**Town of Kittery
 Planning Board Meeting
 May 10, 2018**

459 U.S. Route One – Mixed-use development – Site and Subdivision Preliminary Plan Review

**RE: Town of Kittery, Planning Board Services
Preliminary Plan Review -The Homestead 459 U.S. Route 1 (Tax Map 60, Lot 24)
CMA #591.115**

SCALE: 1" = 40'
DATE: 02/08/2018
JOB NO: C052-18
APPROVED BY: *[Signature]*
FILE: THE HOMESTEAD BASE
DRAWN BY: BRN
REVISION: DATE
F: 04/19/2018
SHEET 2.1

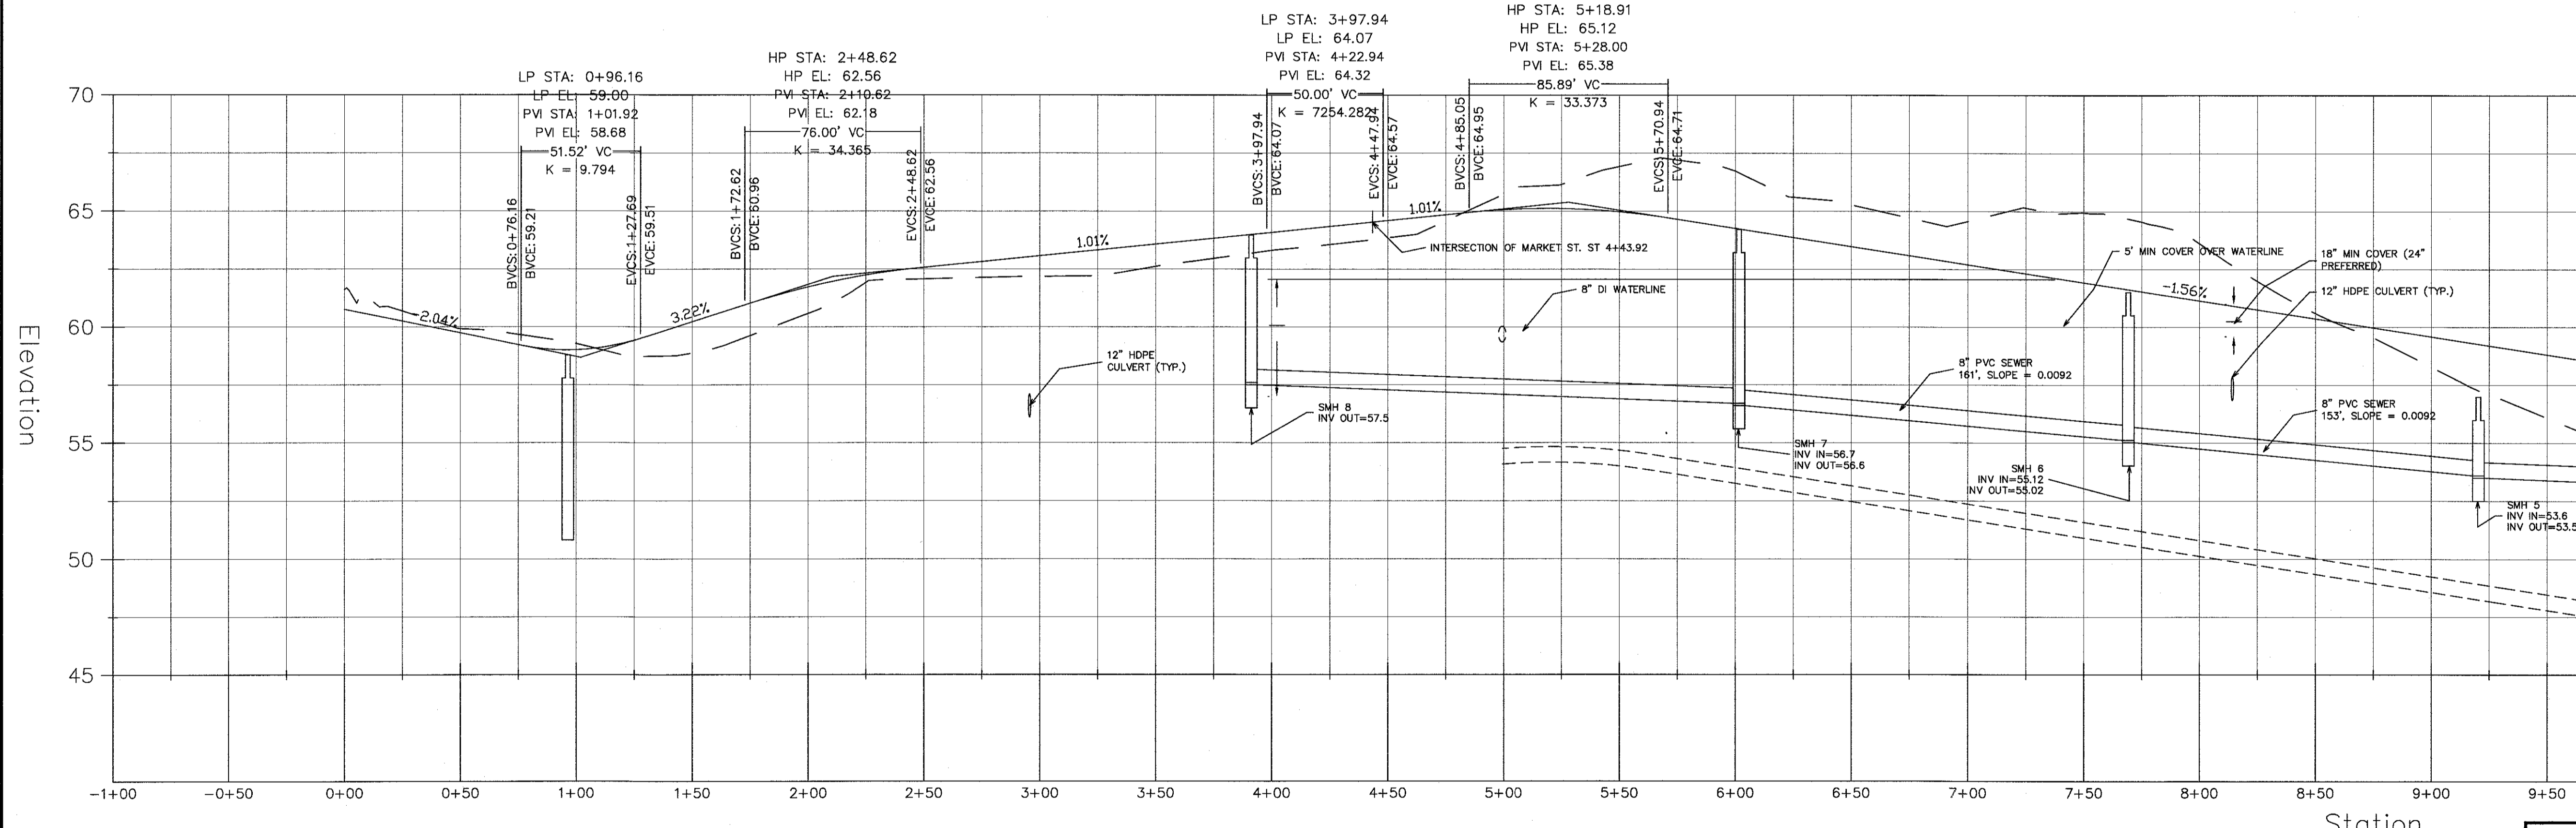
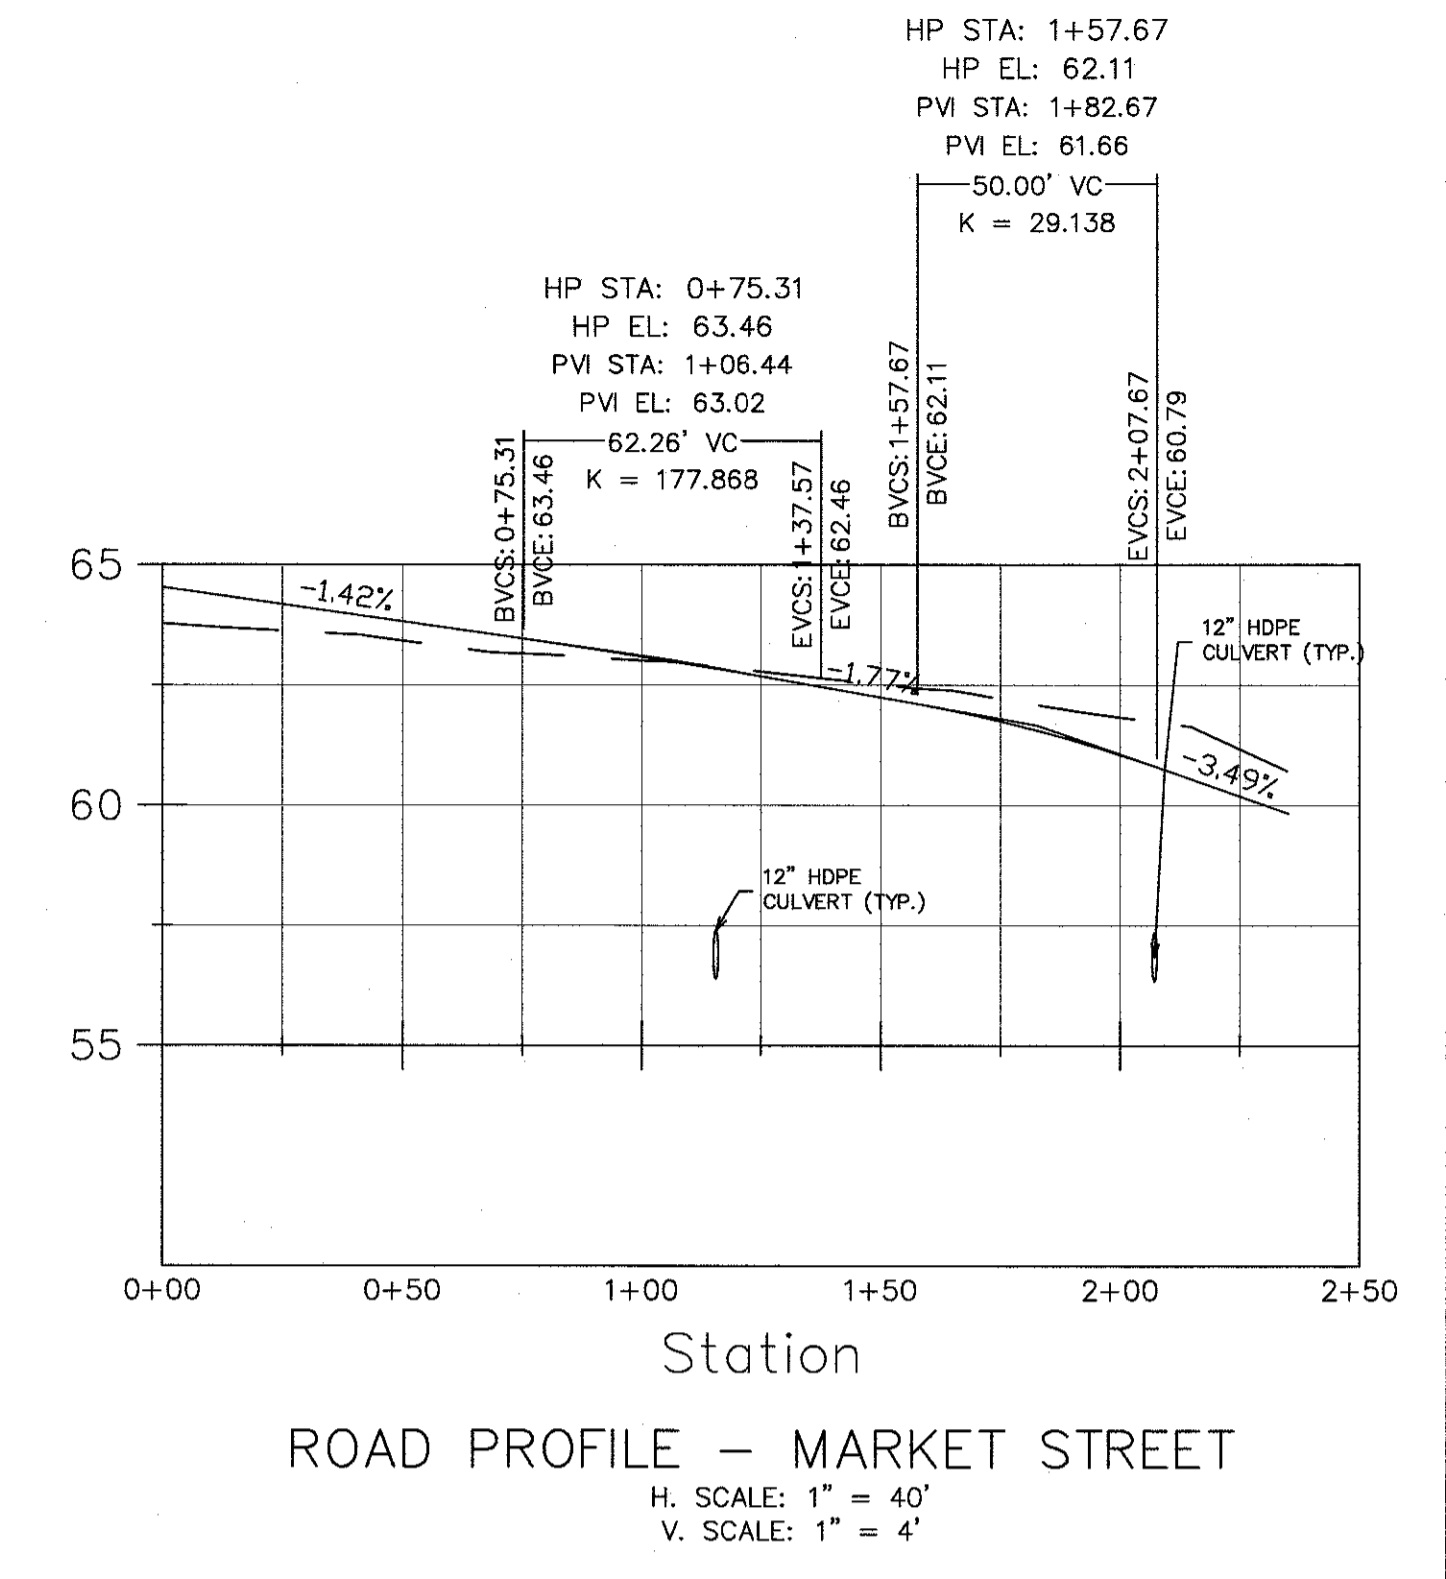
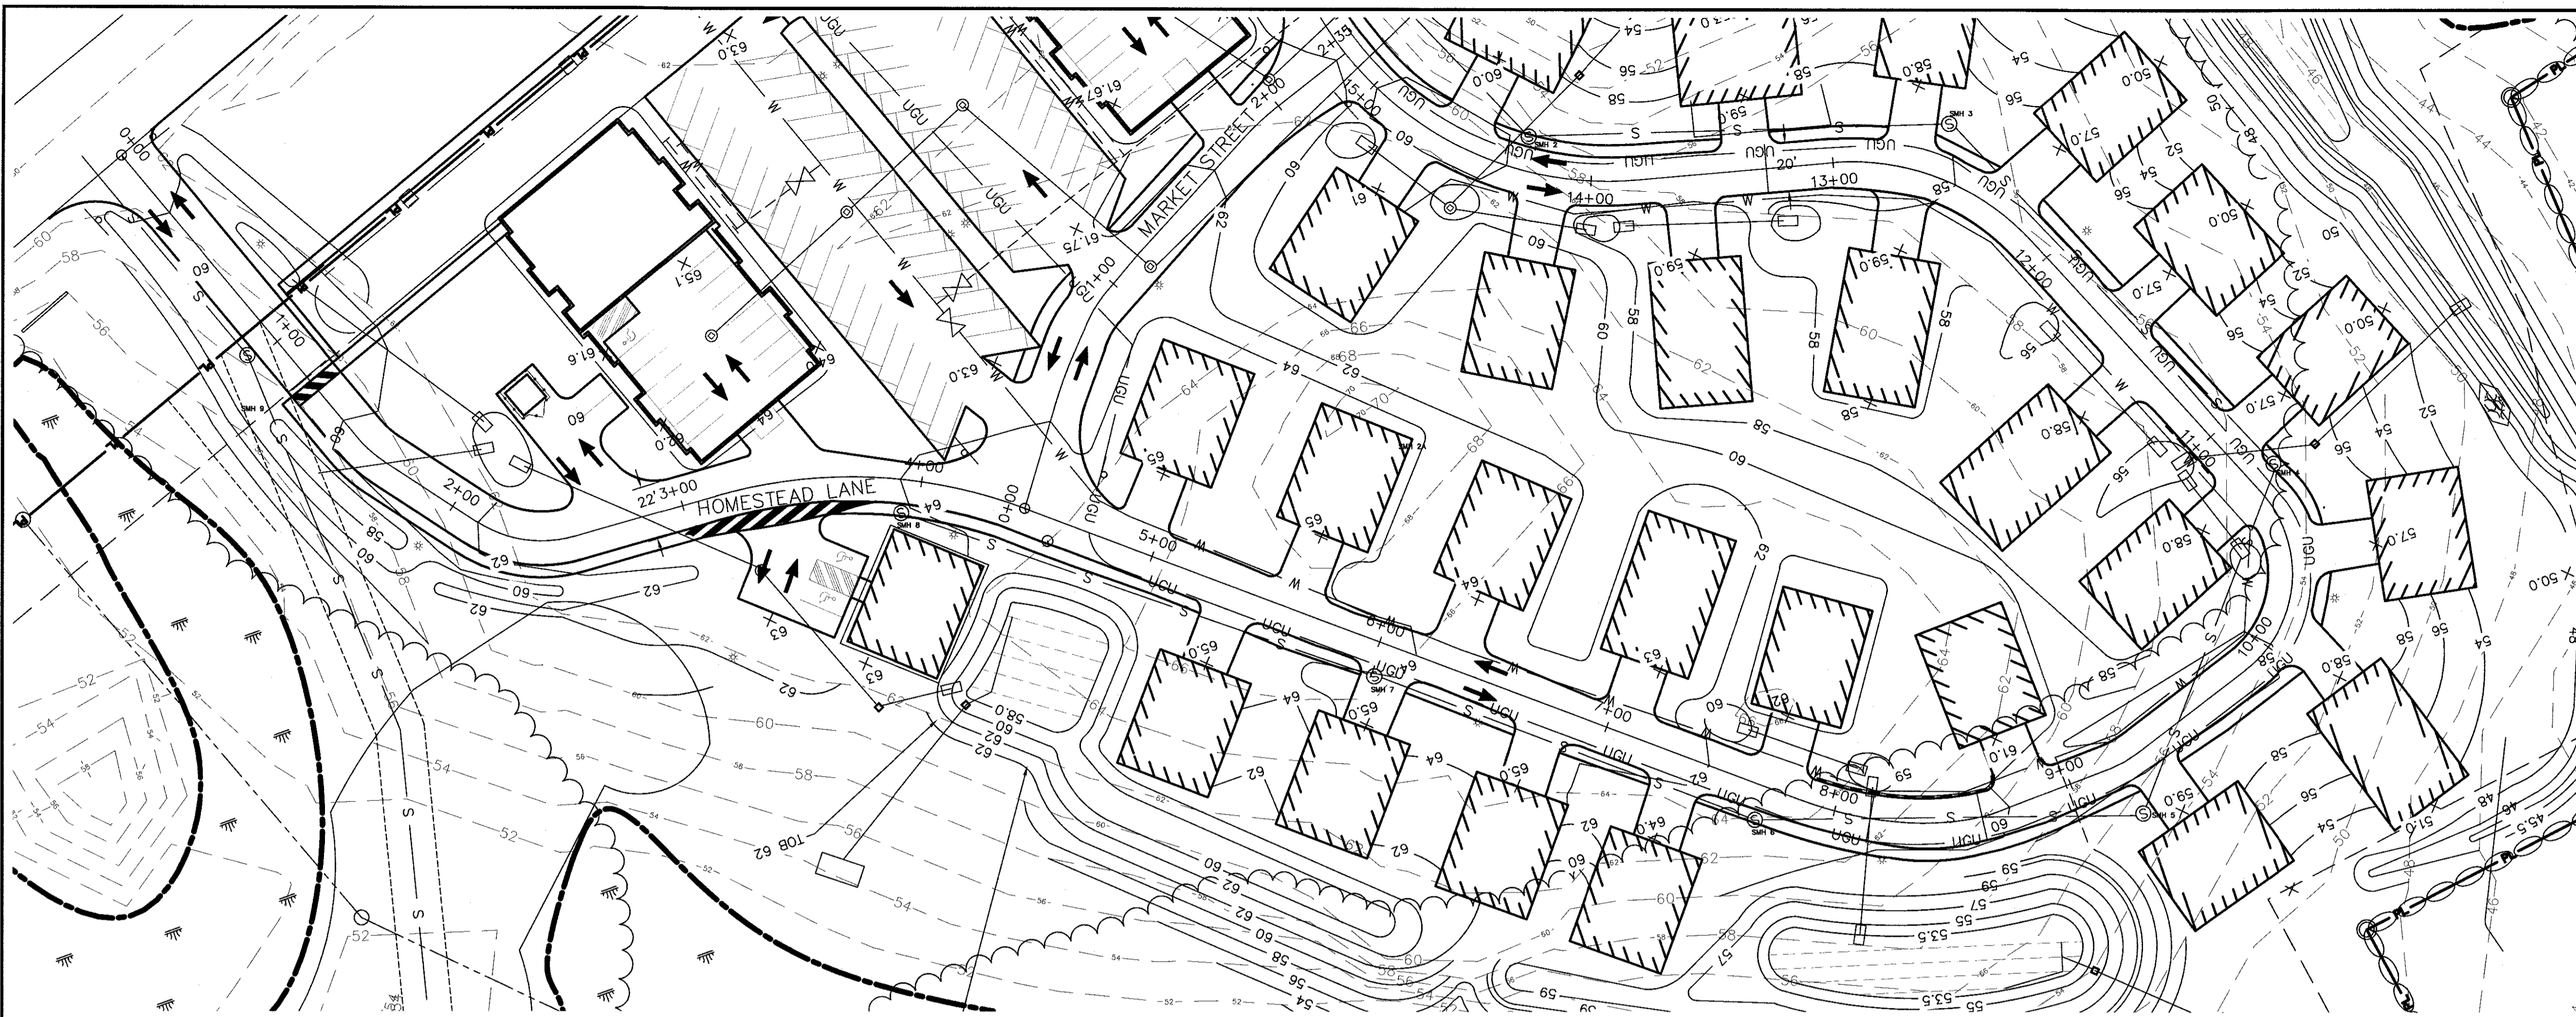
14. On Plan Sheet 2.1 and perhaps others, an arrow labeled “retaining wall” does not seem to point to anything. Is there a wall proposed? Update: arrow and label have been removed.

UNDERDRAINED SOIL FILTER POND 40P

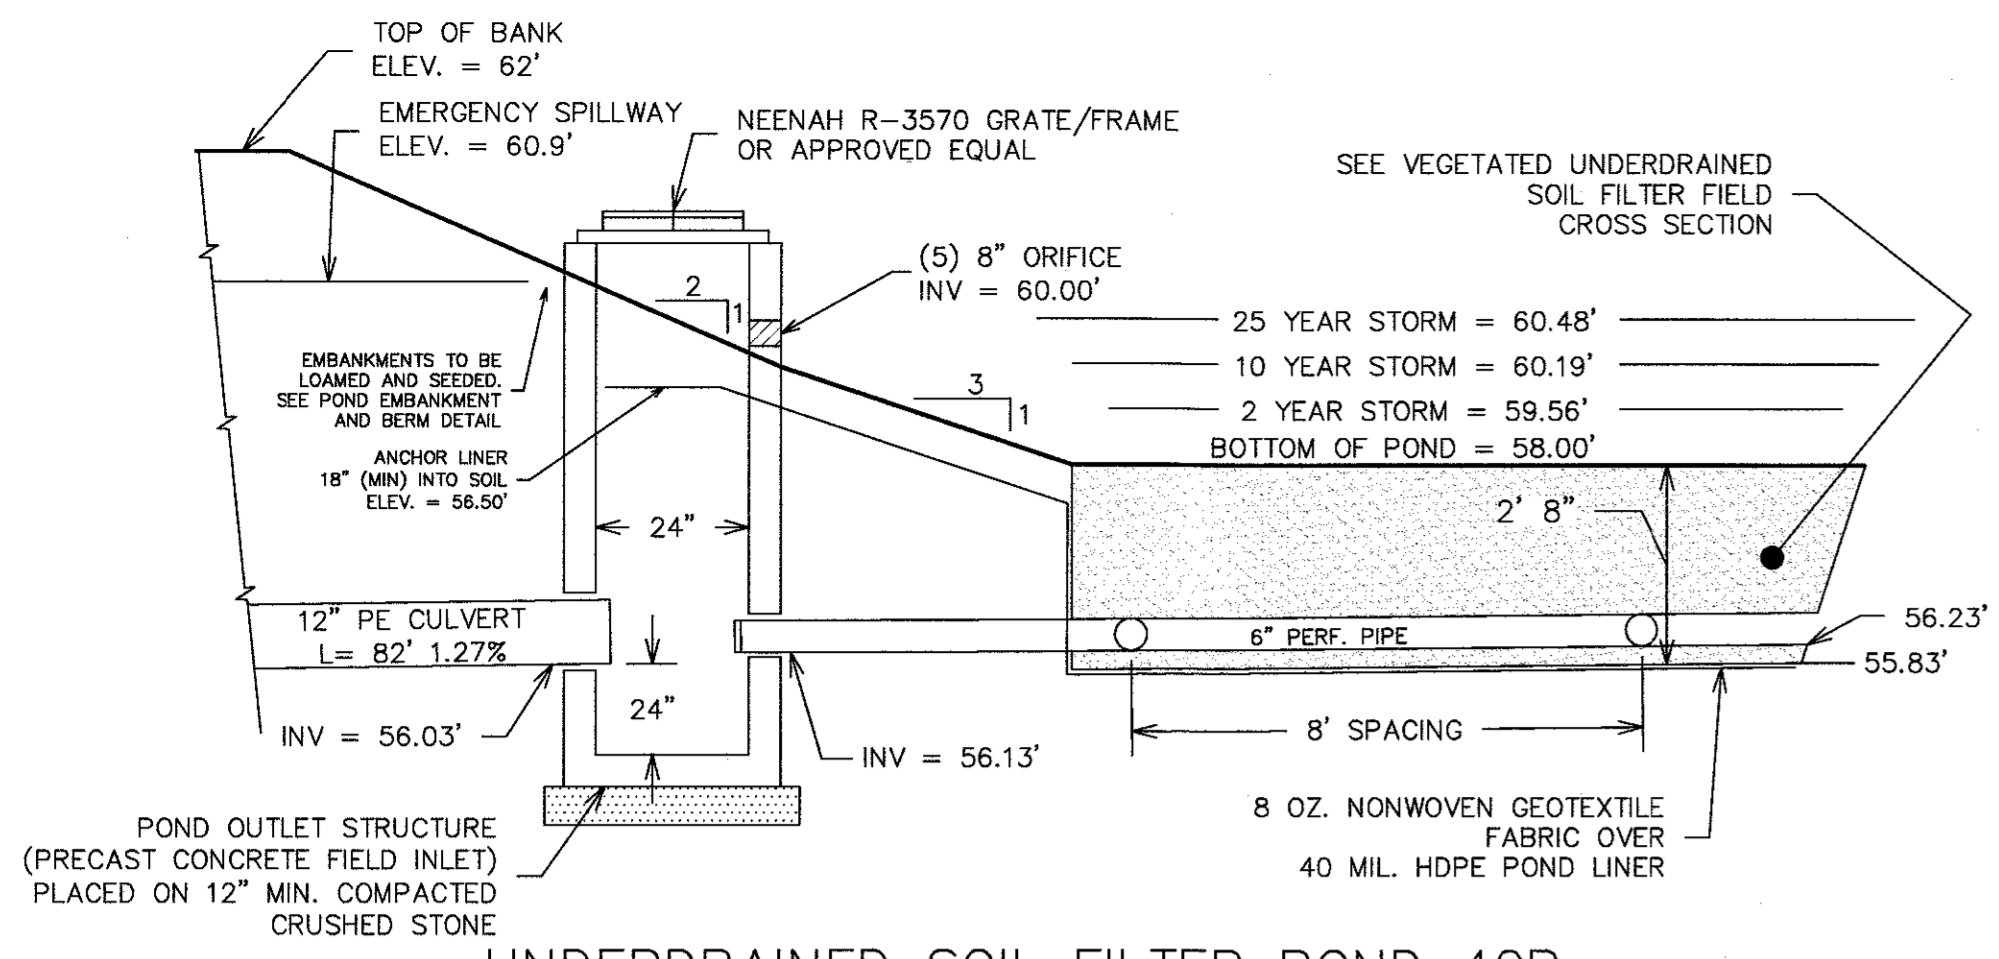
- HydroCAD Model
 - The model pages in my application were mixed up, however I was able to review the model.
 - The underdrained soil filters have outlet control structures with "Horiz. Orifice/Grate"s. The elevation of the "Horiz. Orifice/Grate"s should be called out on detail sheet 5.3 so they can be checked against the model inputs.
 - The outlet control structure invert for pond 10 on sheet 2.1 (42.03) does not match invert in model (40.03). There is a problem with pond 40 also.

- 6) Soil Filter Pond – UDSF Pond 40P invert has been revised.
- 7) Parking Lot Design – Additional dimensions, an accessible route and landscaping trees have been added and/or revised.

UNDERDRAINED SOIL FILTER POND 20P

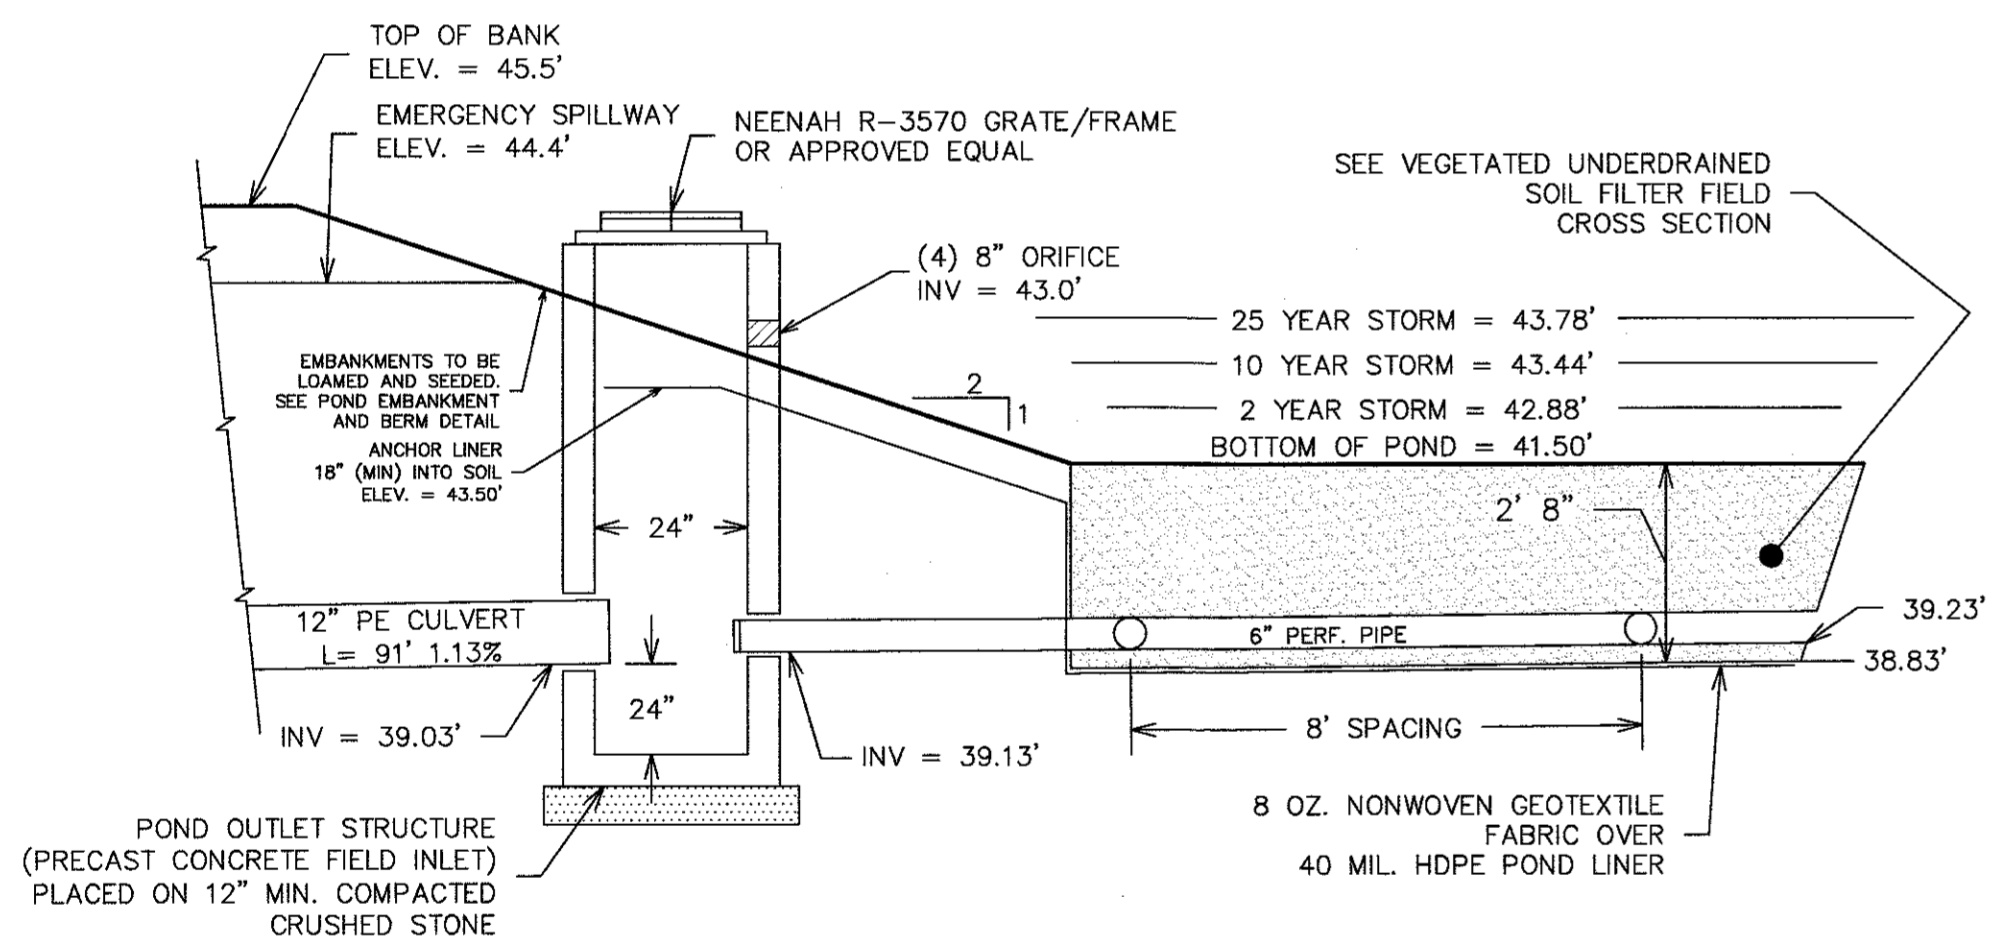
We have the following comment on Sheet 5.3:

- The detail for Underdrained Soil Filter Pond 20P shows an incorrect emergency spillway elevation.
